**STATE OF CONNECTICUT
CONNECTICUT SITING COUNCIL**

Petition of Bristol Solar One, LLC for Declaratory Ruling, Pursuant to Conn. Gen. Stat. §§4-176 and 16-50k, for the Proposed Construction, Maintenance and Operation of a 3.25 MW AC Solar Photovoltaic Electric Generating Facility Located at 399 Hill Street, Bristol, Connecticut, and Associated Electrical Interconnection

Petition No. 1421

**BRISTOL SOLAR ONE, LLC'S RESPONSES TO THE CONNECTICUT
SITING COUNCIL'S FIRST SET OF INTERROGATORIES**

Figure 1: Greenhouse Gas Emissions over 20-years for Natural Gas Scenario vs. Solar Scenario per 118,949 MWh

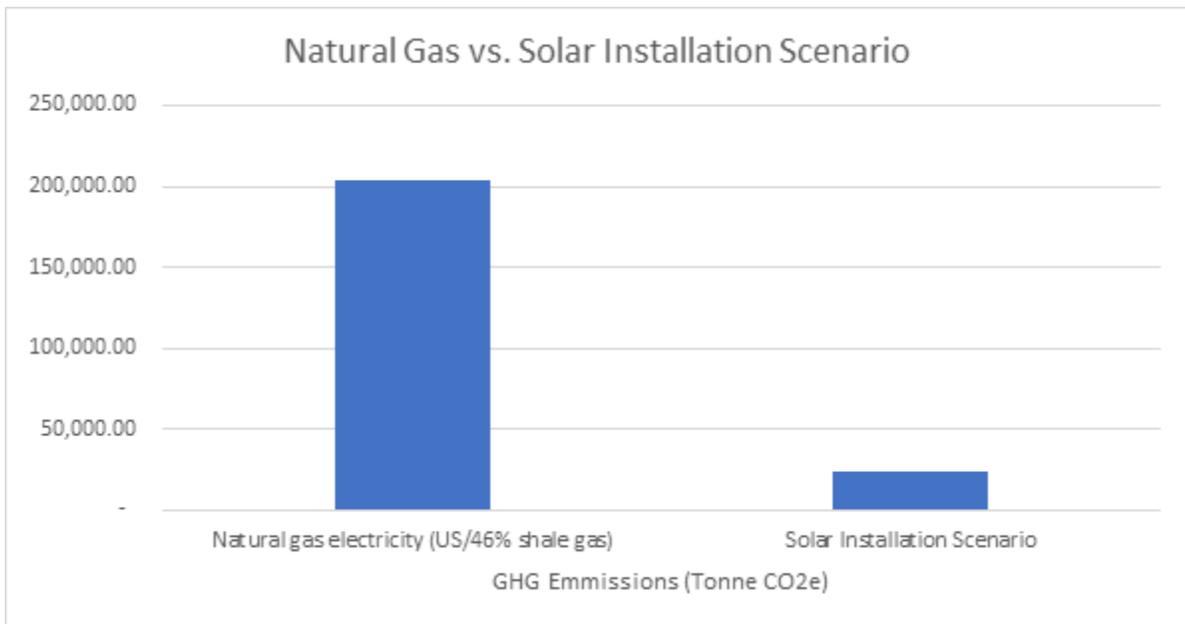
27. **The Greenhouse Gas (GHG) Assessment in Appendix M of Council Petition No. 1352 compared the life cycle GHG emissions from a solar project to a scenario where the solar project is avoided and an equivalent amount of natural gas-fired electric generation operated for the estimated life of the solar facility. For the proposed project, how would the net GHG emissions (or reduction) over the life of the solar facility and carbon debt payback be affected under this natural gas-fired generation versus proposed solar generation scenario?**

Using the methods and general assumptions provided in Appendix M of Council Petition No. 1352 as a foundation and applying those principles proportionally to the subject project (Petition No. 1421), Petitioner estimates that there would be an 89% reduction in GHG emissions by pursuing solar instead of natural gas.

Specifically, over 20 years, Petitioner estimates the instant solar project (“Project”) will generate 118,949 MWh of electricity, while emitting approximately 23,160 tons of CO_{2e}. To achieve the equivalent MWh production over 20 years as the Project, a natural gas generator would emit an estimated 203,651.55 tons of CO_{2e}. See Figure 1 on the next page.
